**MEETING OF THE
PLANNING AND ZONING BOARD
QUASI-JUDICIAL PUBLIC HEARING**

April 5, 2017

Subject: Site Development Plan Application – 2nd Review
Capriccio - 30 DU Multi-Family Residential Complex
9880-9900 W. Bay Harbor Drive
Bay Harbor Islands Acct. No. MB2016-142
MMPA Acct. No. 01-0702-1044

2 EAST (FRONT) ELEVATION (3D VIEW)
SCALE: $\frac{3}{8}" = 1'-0"$

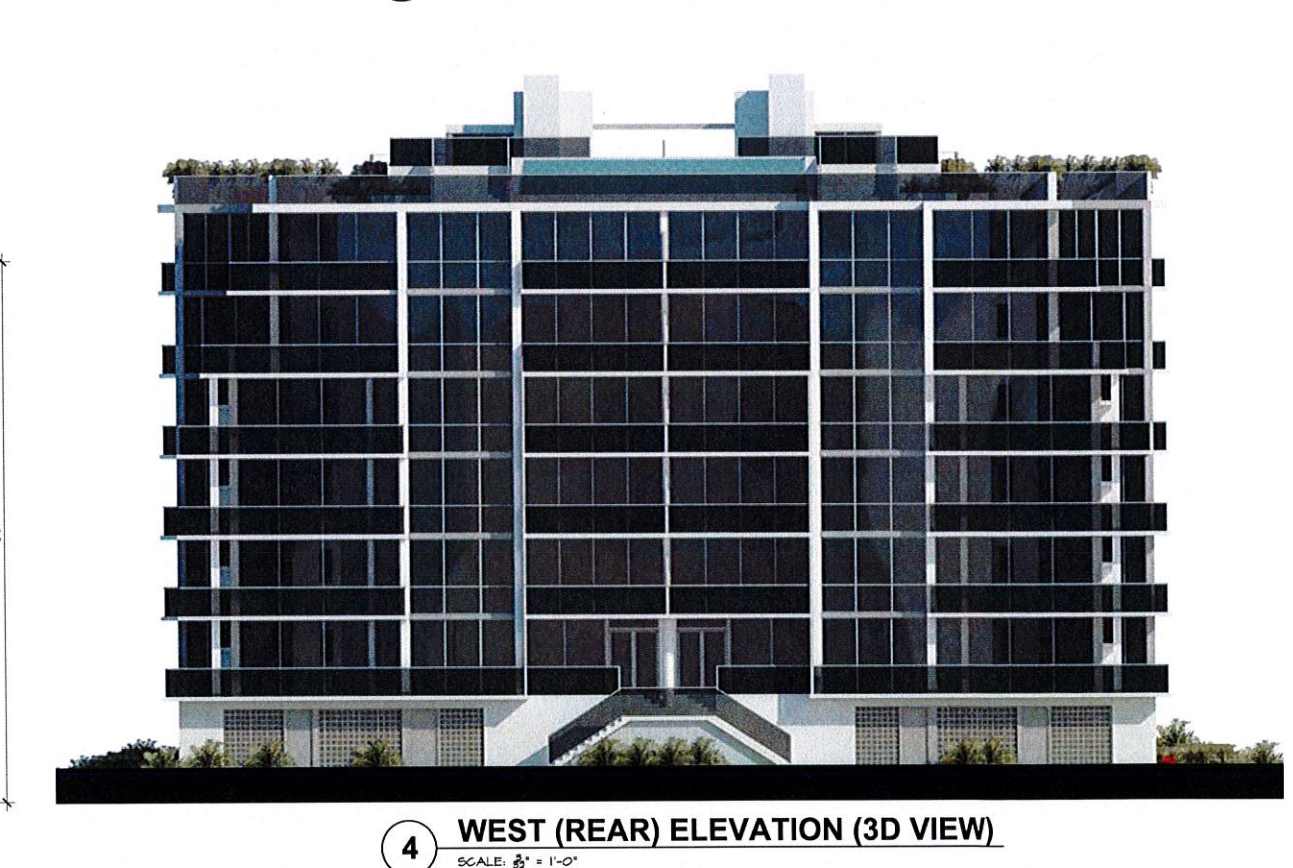
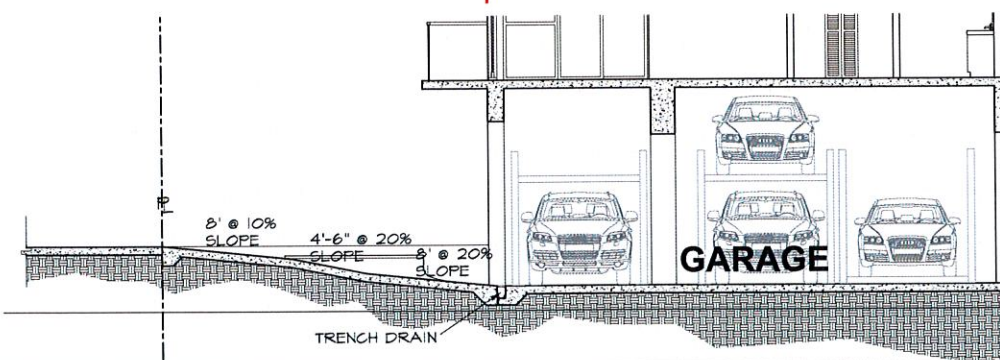
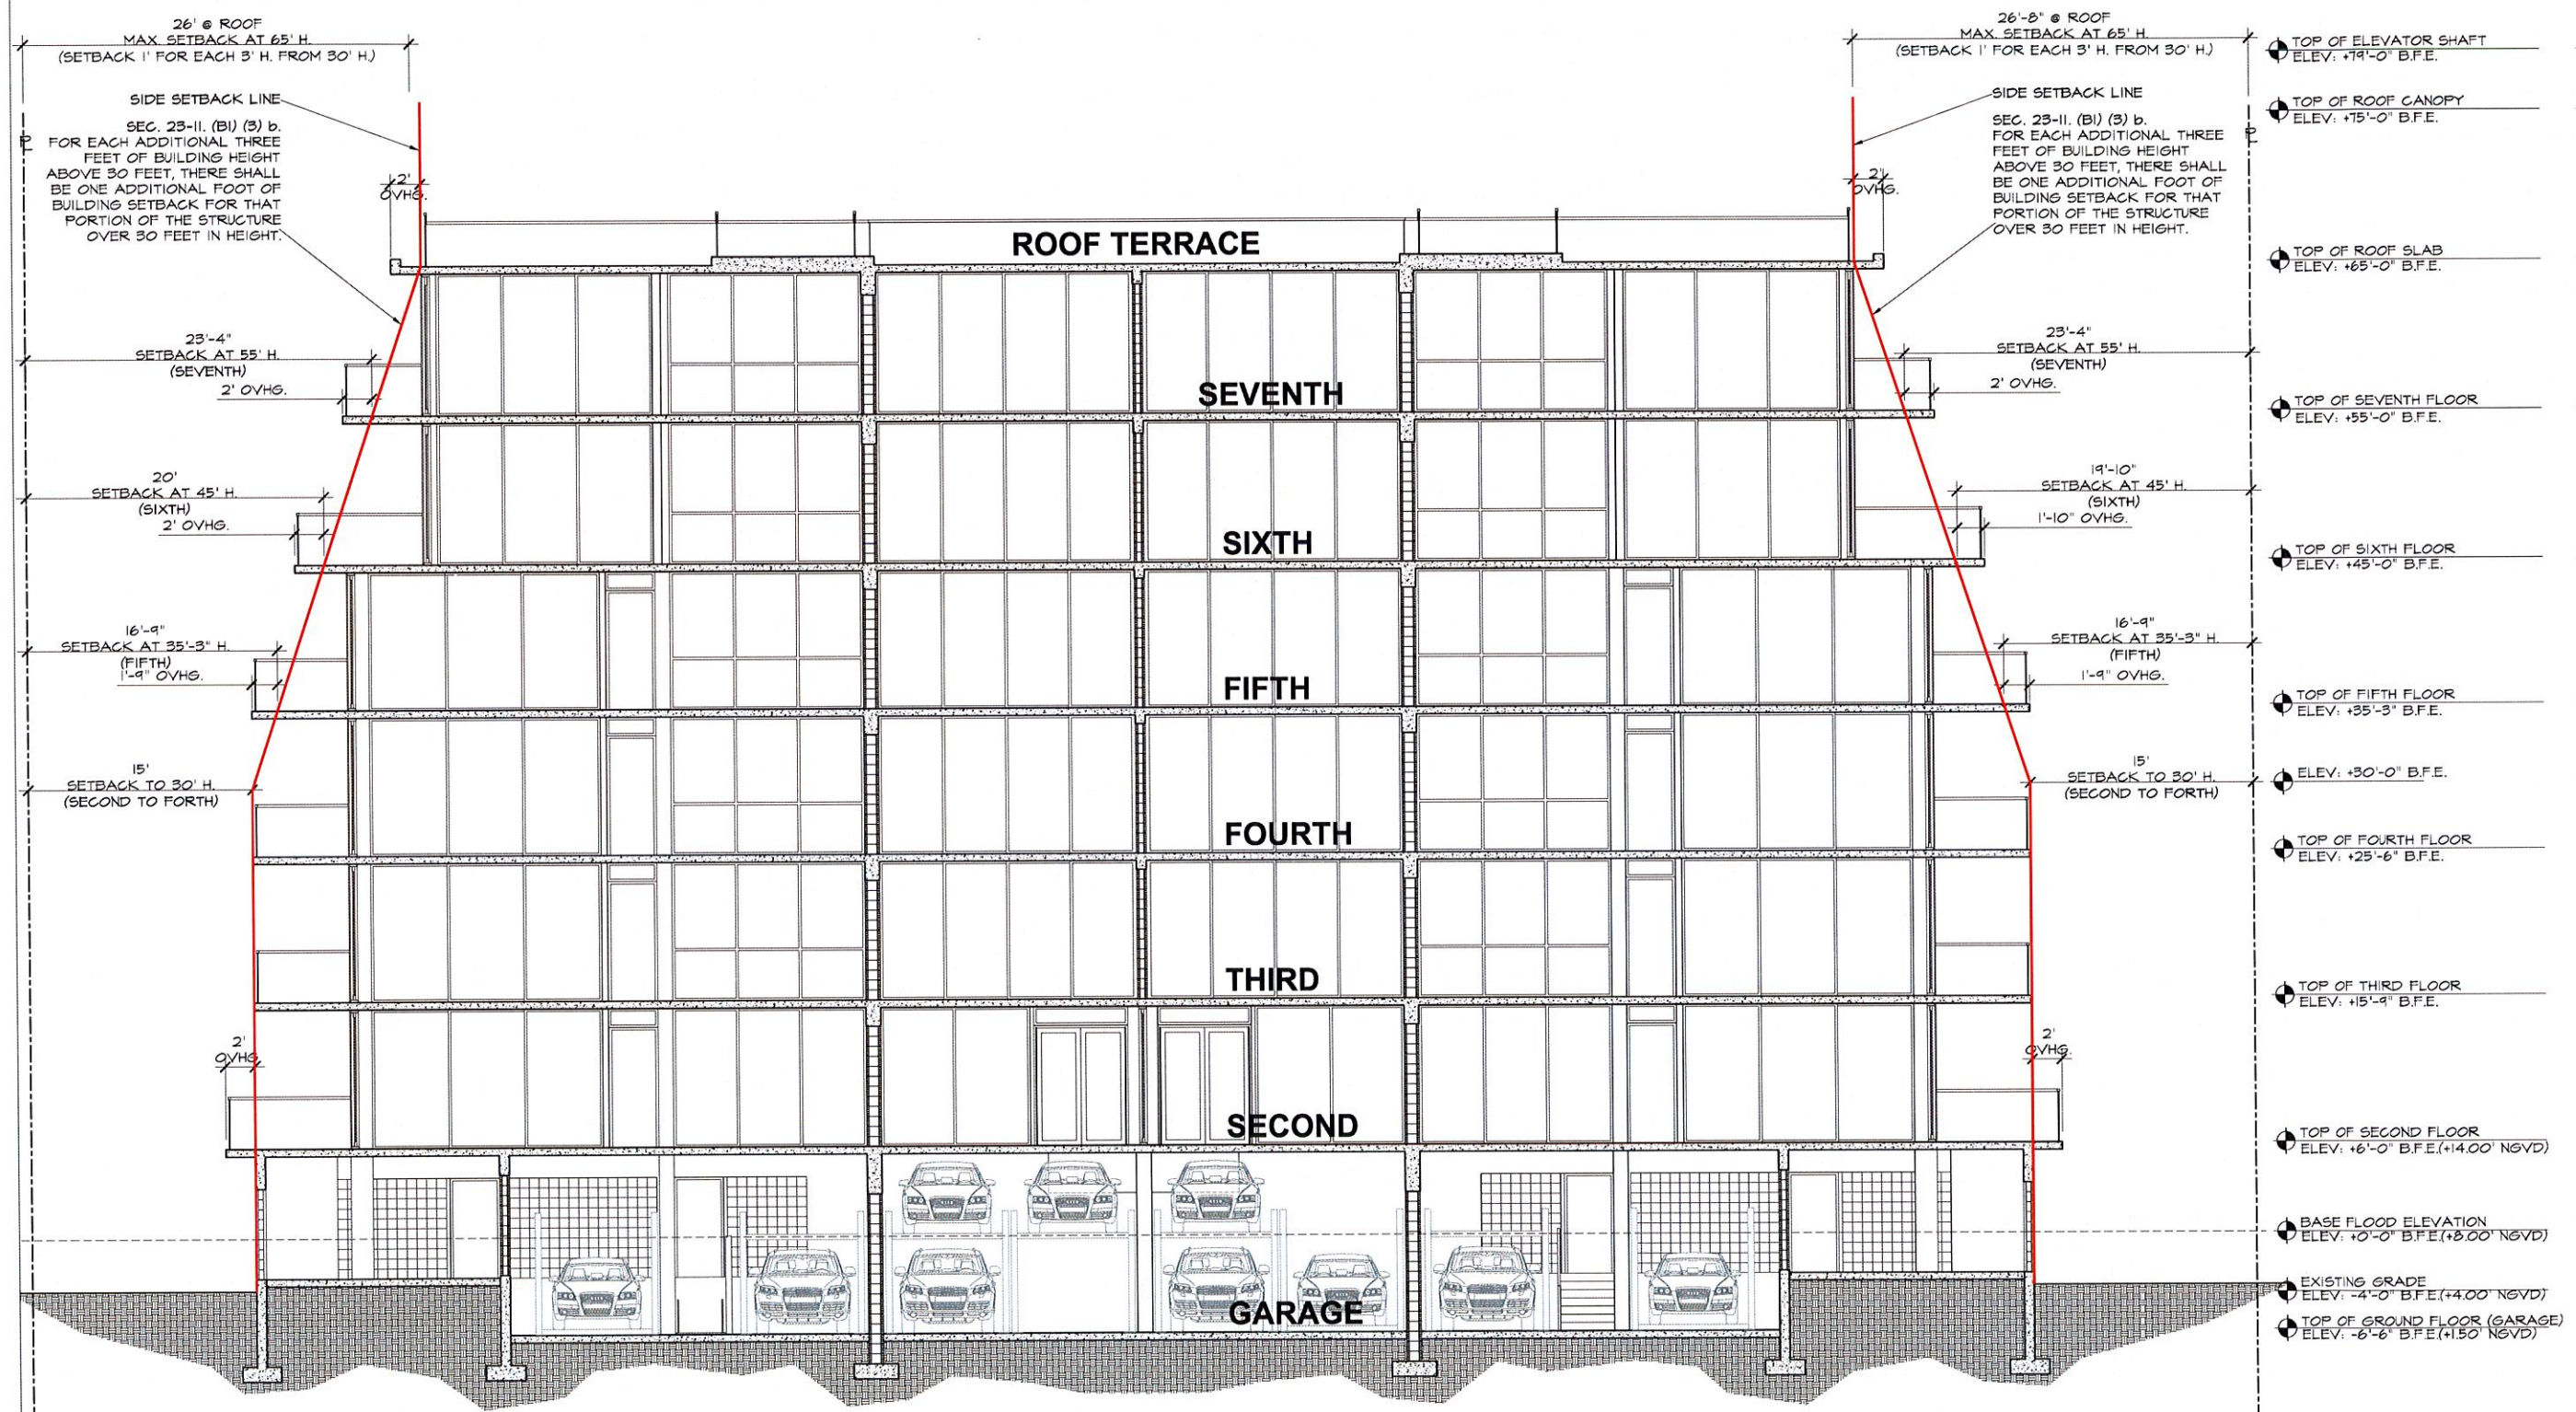
3. *Provide further stair (front / rear) details.*

The applicant has provided additional renderings of the front and rear stairs to show greater detail. Both staircases cascade from the 1st Level to the ground in the setback areas.
